MEMORANDUM

SUBJECT: Limited Functional Master Plan Amendment for the Intercounty Connector (ICC)
-- Bikeways and Interchanges

PLANNING BOARD DRAFT OF THE INTERCOUNTY CONNECTOR LIMITED FUNCTIONAL MASTER PLAN AMENDMENT

Figure 4 Needwood Road Options

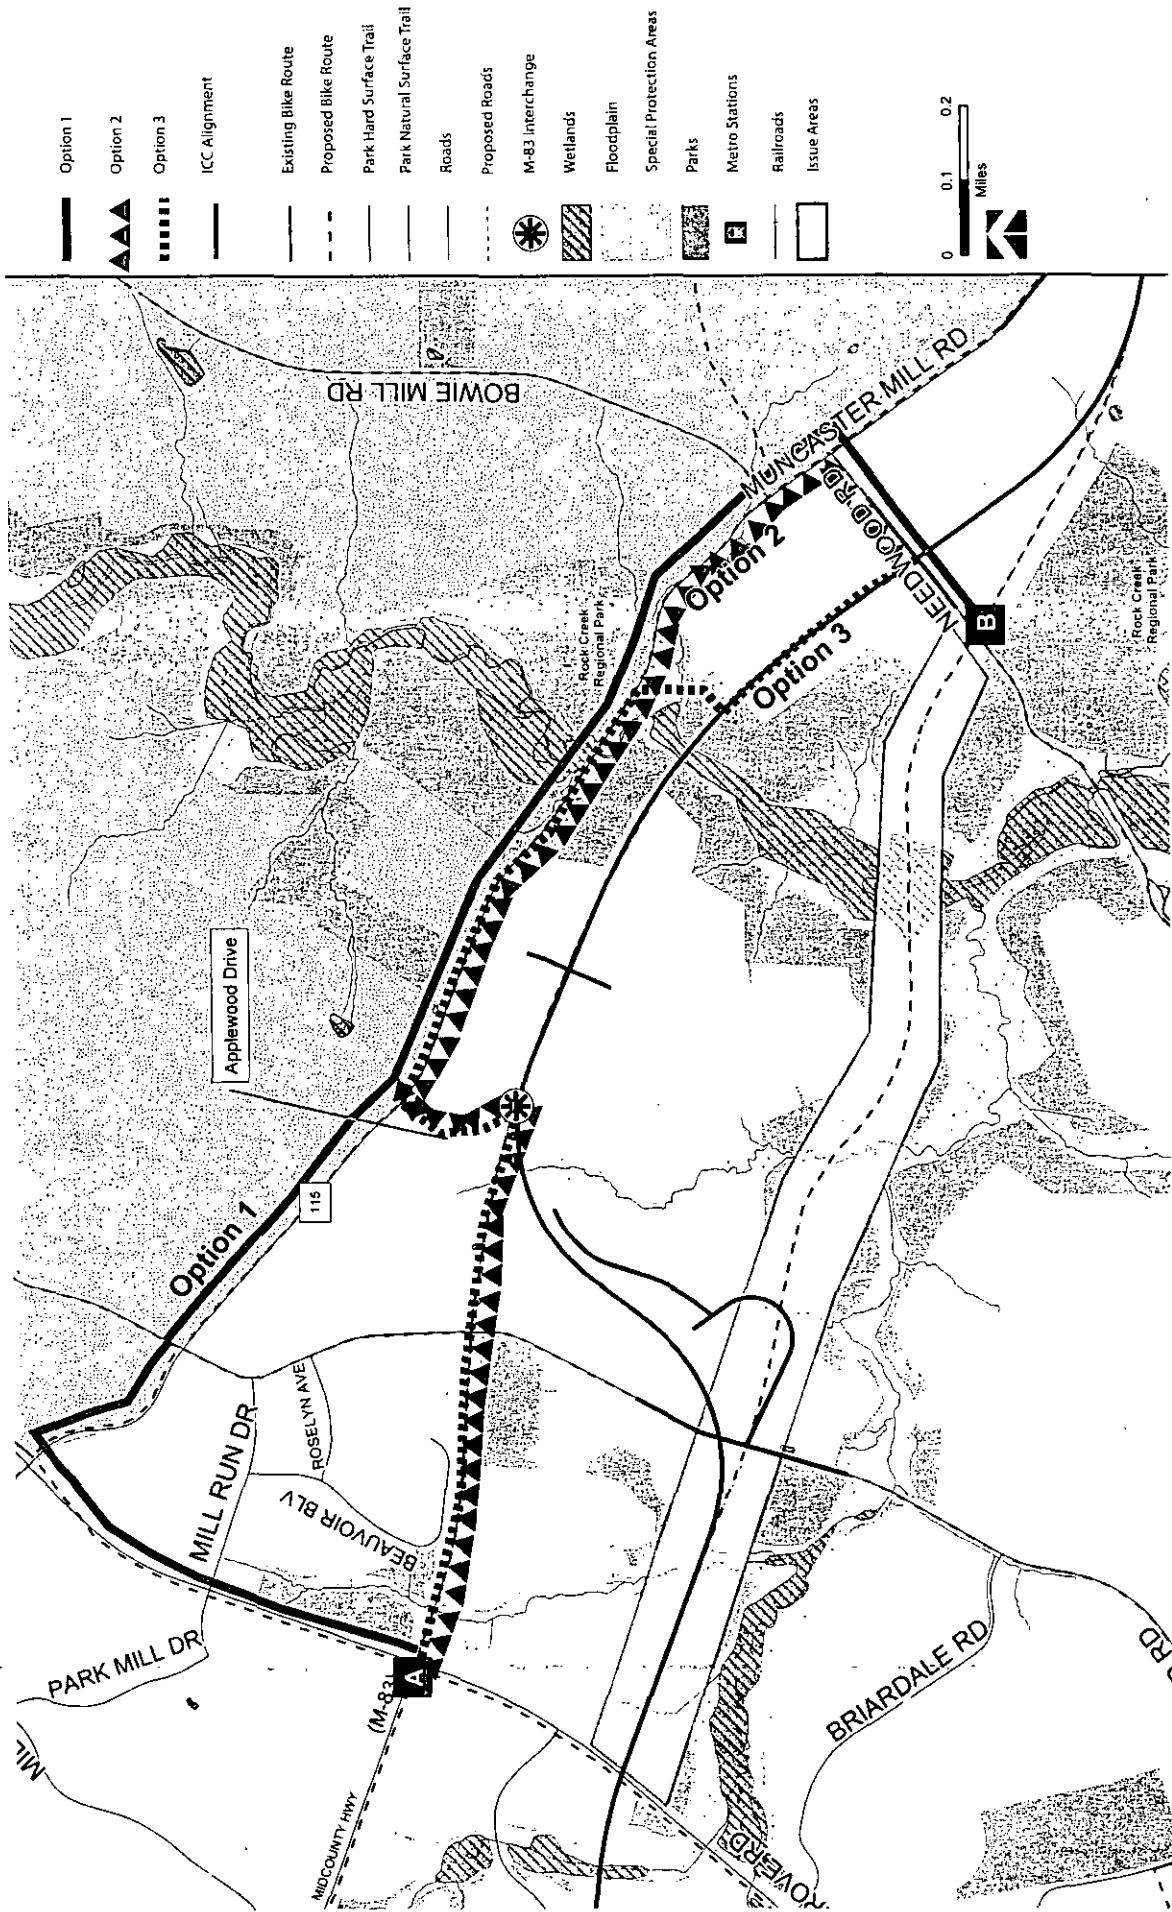
4. For Needwood Road and Vicinity (Study Area A), we support Option 2, primarily because it follows the ICC alignment more closely than Option 1 and appears to have less negative impacts on the natural environment than Option 3.

- p. 16 correct spelling of Applewood Lane
- p. 18 it is inconsistent to show any of “Option 1” along Shady Grove Road; this is not what the text indicated

The Board recommends carrying the shared use trail along Needwood Road northeast to Muncaster Mill Road, and from there west along the south side of Muncaster Mill Road to Applewood Lane, where it would connect with the existing shared use path extending west to Shady Grove Road. This is Option 1 on ©7 (page 18 of the Final Draft). The Board also recommends a shared signed roadway (a Class III bike route) be designated on Applewood Lane connecting to a future shared use trail west along the M-83 right-of-way. This is Option 2, and is the preference of DOT as well.

Council staff recommendation: Concur with the Final Draft.

Figure 6 Northwest Branch Stream Valley Park Options

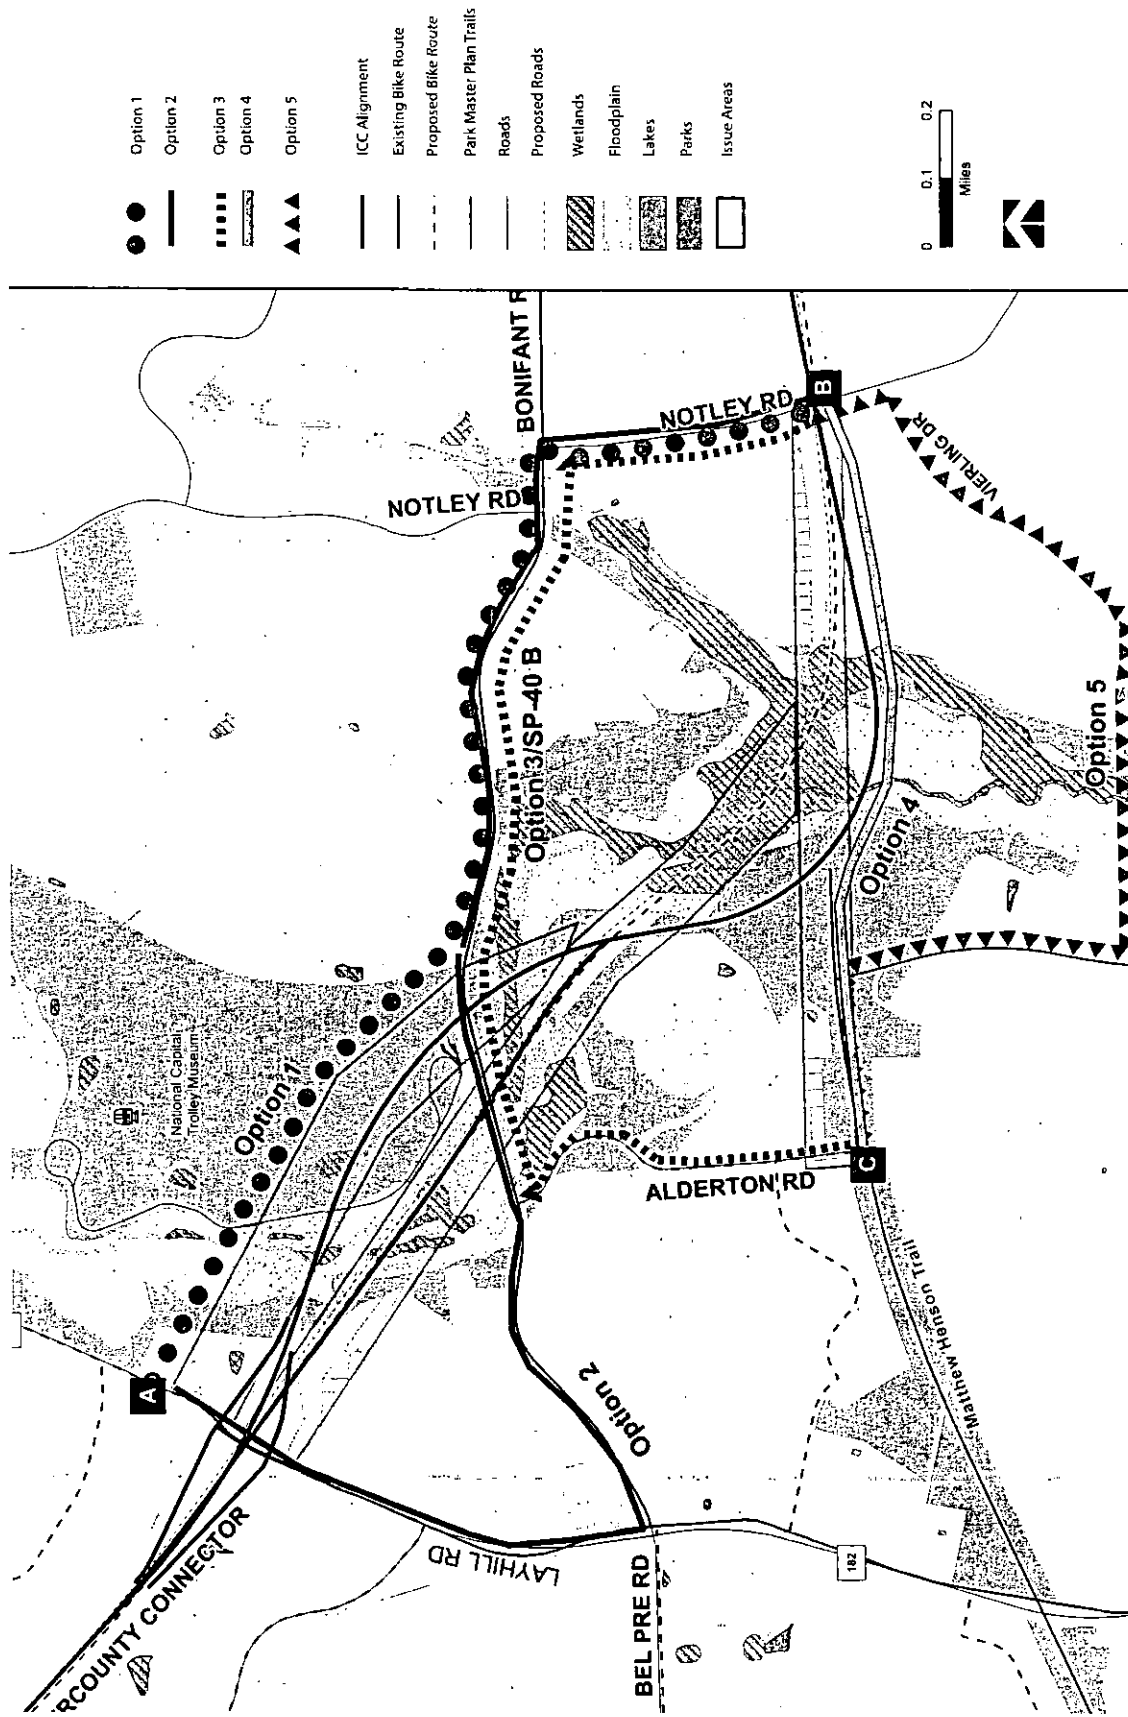
DOT recommends including in the plan the portion of Option 1 between Layhill and Bonifant Roads, the portion of Option 3 west on Bonifant Road and south on Alderton Lane, plus Option 4 connecting across Northwest Branch from the eastern terminus of the Matthew Henson Trail to Notley Road.

The detour to avoid Northwest Branch Park south of Bonifant Road follows along that road and Notley Road. It does not add length but adds some number of residential driveway crossings and a few street crossings. Any sidepath built along Bonifant (useful in its own right) must absolutely be located on the south side of the street (crossing at

Pebblestone Drive) to avoid the much greater number of driveways on the north side. The original route through the park must remain in the master plan until it has at least been the subject of a facility design study.

Council staff recommendation: Include Options 1, 3 and 4 in the plan. The Bonifant/Notley route is the most direct between the eastern and western segments of SP-40. Option 3 is the most direct feasible route between the Henson Trail and the western segment of SP-40. Finally, Option 4 is the best connection between the Henson Trail and the eastern segment of SP-40.

Figure 2 Midcounty Highway Interchange

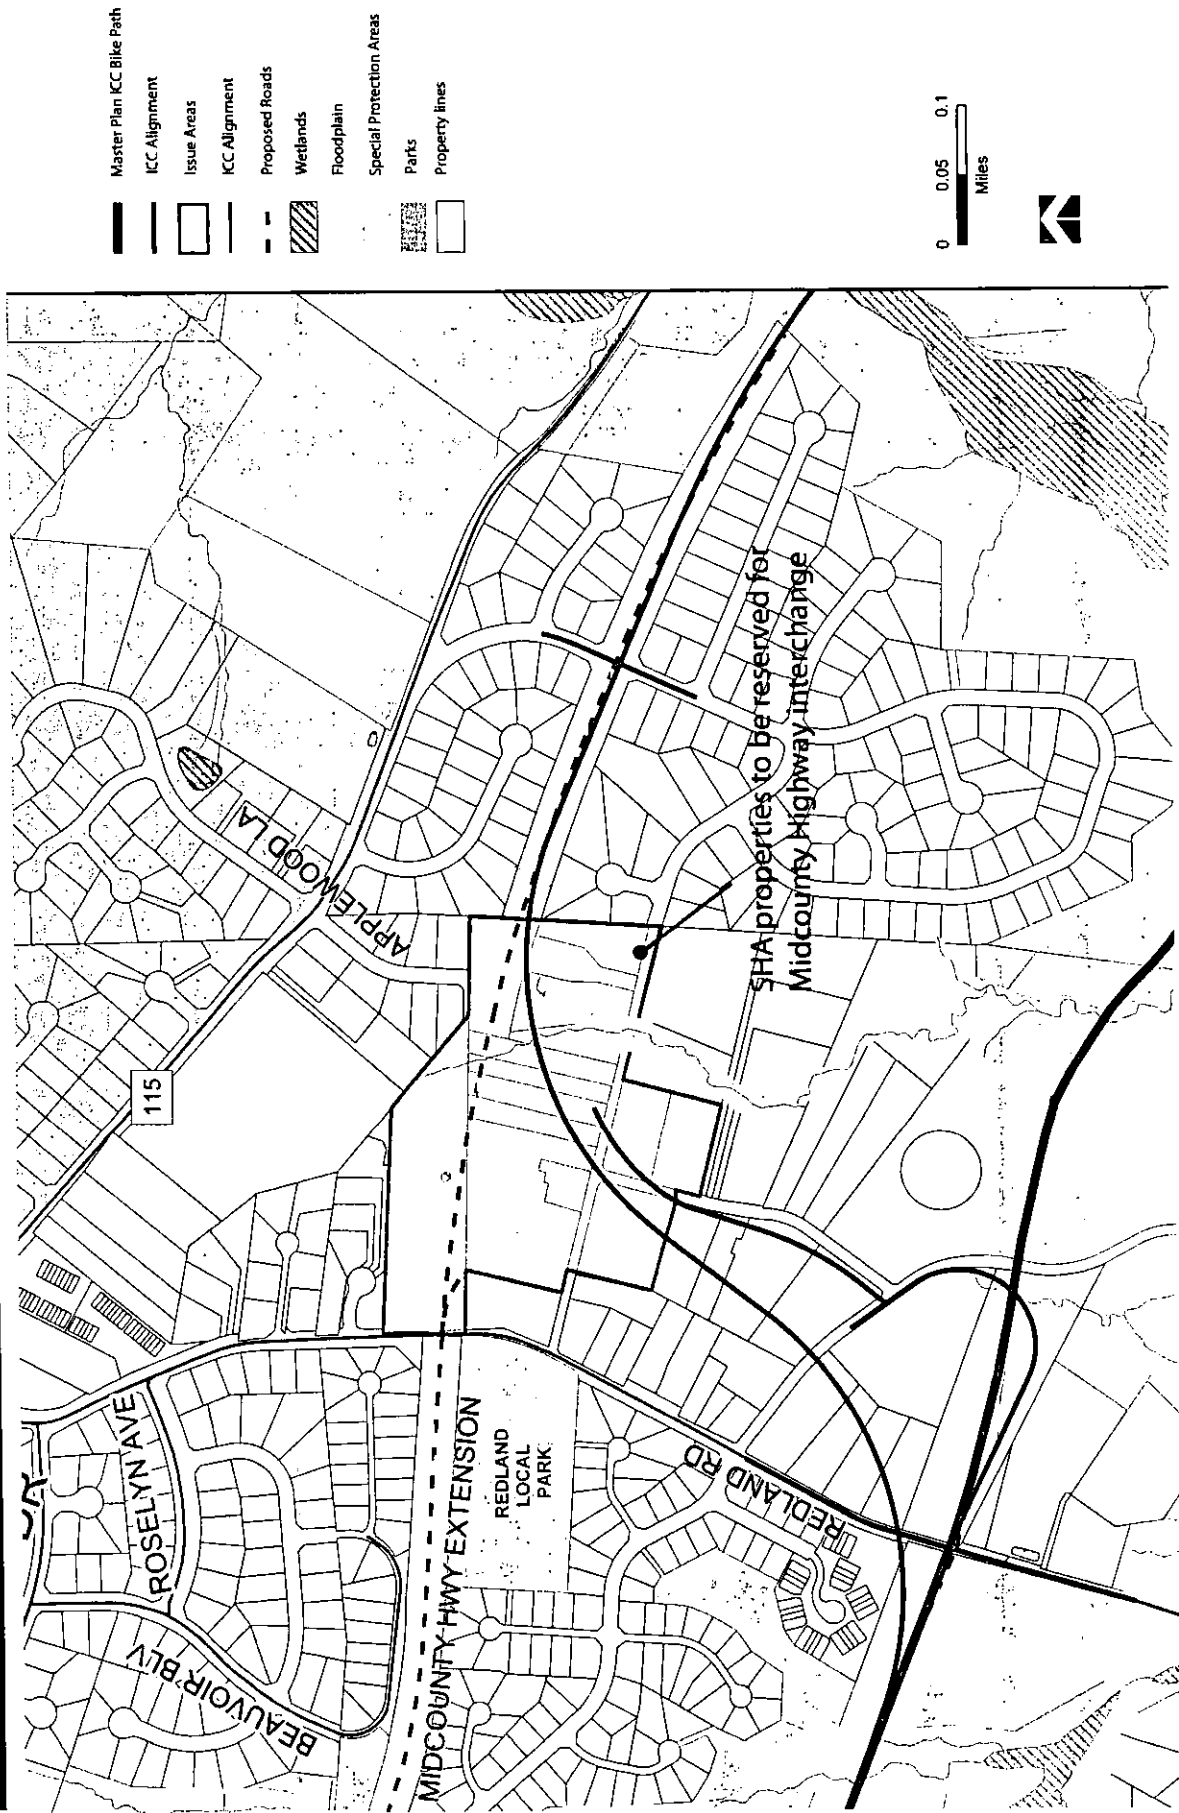
I am writing to submit testimony into the public hearing record for the above-referenced plan. I am the owner of lot 4, block A at the southwest corner of Garrett and Overhill Roads. On Figure 2 (page 12) of the Planning Board Draft my property is shown as one of the "SHA properties to be reserved for Midcounty Highway Interchange."

At the time the plan was prepared the State did not own my property but rather had initiated condemnation proceedings. This case was recently settled out of court. The State has agreed that it does not need my entire property and, in fact, as part of the settlement is transferring some of the property it owned on the north side of Garrett Road to me (see enclosed drawing).

I am requesting that Figure 2 be revised to show the new boundaries agreed to by the State. Our future plans for redevelopment could be placed in jeopardy if the property is shown as being recommended for reservation. Thank you for your attention to this matter.
